Access Compliance Report

Public Rights-of-Way

(Curb Ramps)

Intersection ID: 10028555	Main Street: HOLLY_HILL_FARM_RD	Cross Street: N/A	Location: W
ADA ID: E4F6E8F4662E	Ramp Type: Perp	Initial Pass/Fail: Fail	Overall Compliance: No
Severity Score: 13.75			
Codes/Mitigation Info/Possible Solution		Field Measurements/Component Compliance

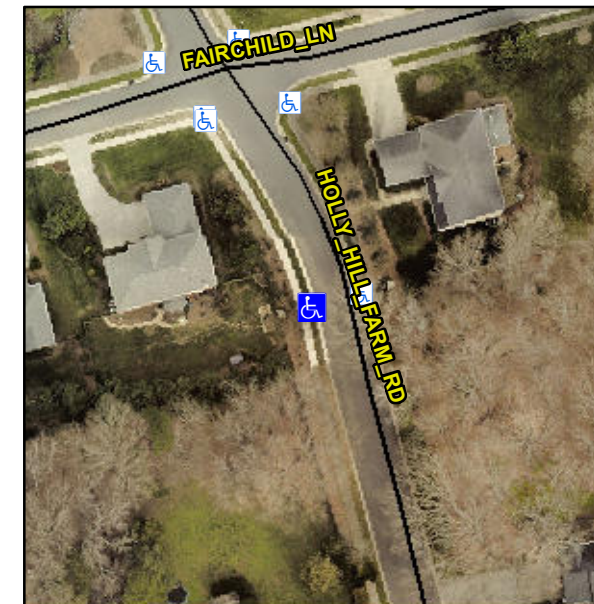
R304.2.2

Compliance	Description	Data	Compliance	Description	Data
N/A	Ramp Length (in)	70.5	No	Ramp Slope (%)	9.8
Yes	Ramp Width (in)	48.0	Yes	Ramp XSlope (%)	3.2
N/A	Flare Type LT	N/A	N/A	Flare Type RT	N/A
N/A	Flare Slope LT (%)	N/A	N/A	Flare Slope RT (%)	N/A
N/A	Flare Traversable LT?	N/A	N/A	Flare Traversable RT?	N/A
N/A	Landing Length (in)	N/A	N/A	DWS Provided?	N/A
N/A	Landing Width (in)	N/A	N/A	DWS Contrast?	N/A
N/A	Landing Slope (%)	N/A	N/A	DWS Length (in)	N/A
N/A	Landing X Slope (%)	N/A	N/A	DWS Full Width?	N/A
N/A	Landing Curb? (Y/N)	N/A	N/A	DWS Offset (in)	N/A
N/A	Shared Landing?	N/A			
N/A	Gutter Ponding?	N/A	N/A	Gutter Slope (%)	N/A
N/A	Gutter Lip Ht (in)	N/A	N/A	Gutter X Slope (%)	N/A
N/A	Painted X Walk1?	No	N/A	Painted X Walk2?	N/A
	X Walk 1 Direction	To E		X Walk 2 Direction	N/A
N/A	X Walk 1 Width (in)	N/A	N/A	X Walk 2 Width (in)	N/A
	X Walk 1 Slope (%)	0.5		X Walk 2 Slope (%)	N/A
	X Walk 1 X Slope (%)	3.4		X Walk 2 X Slope (%)	N/A

Remove & Replace Entire Ramp.
